Conceptual Review Agenda

220 E Olive St Townhomes

Request for Standalone Zoning Modification

Project: Townhomes at Library Park
Location: 220 East Olive Street
Applicant/Owner: Olive Street Properties, LLC
c/o Brad Florin
PO Box 270070
Fort Collins, CO 80527

Exhibit 3

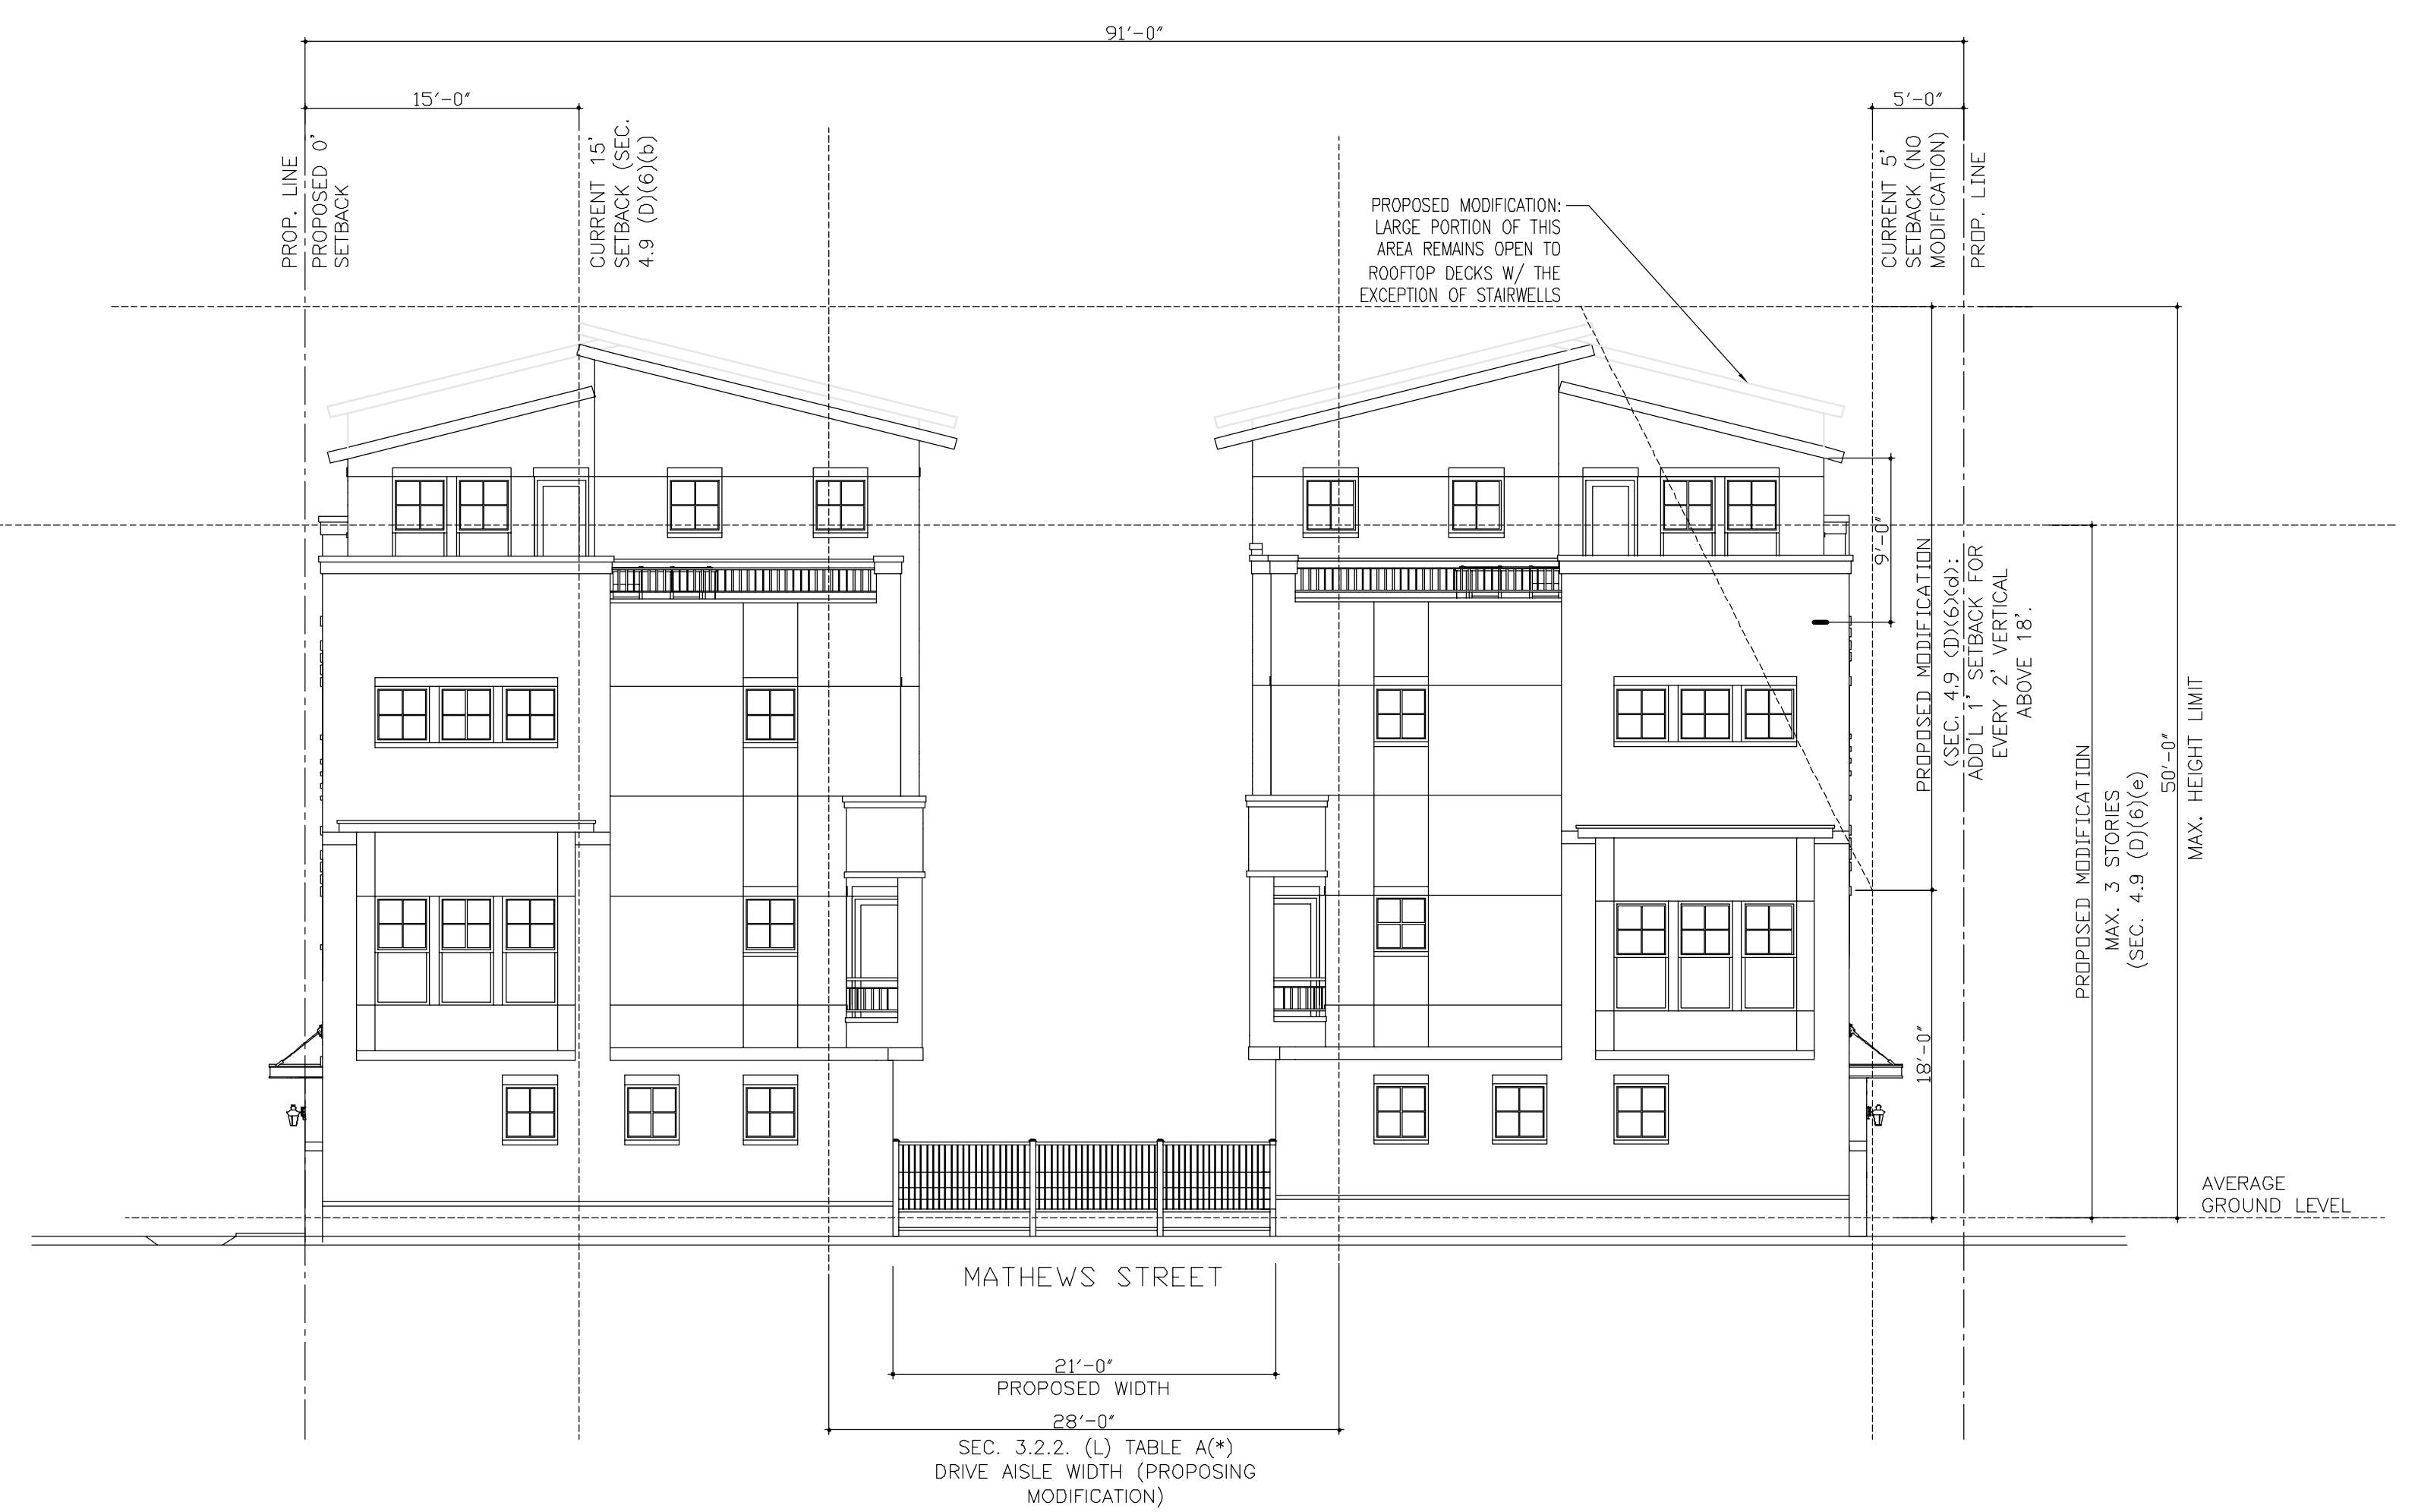
2. The north side setback modification based on wall height needs additional clarification. i.e., the request clearly needs to state that the modification request is to allow the required north side setback to be reduced from 17' to 5'.

3. With regard to the 8th modification - driveway width: The standards in Sec. 2.8.2(H)(4) is NOMINAL, inconsequential. This means that the request deviates from the standard in a nominal AND inconsequential way. The applicant has indicated that their request is only inconsequential. That doesn't satisfy the

standard. Additionally, a 21' driveway width is a concern when it comes to adequately being able to enter and exit the garage without having to make numerous turning movements and attempts. Snow conditions will also add to the problem.

7. As depicted on the site plan, Olive Street will need to be altered with the more standard parkway landscaping between sidewalk and street.
8. Utility plans will be required and a Development Agreement will be recorded once the project is finalized.
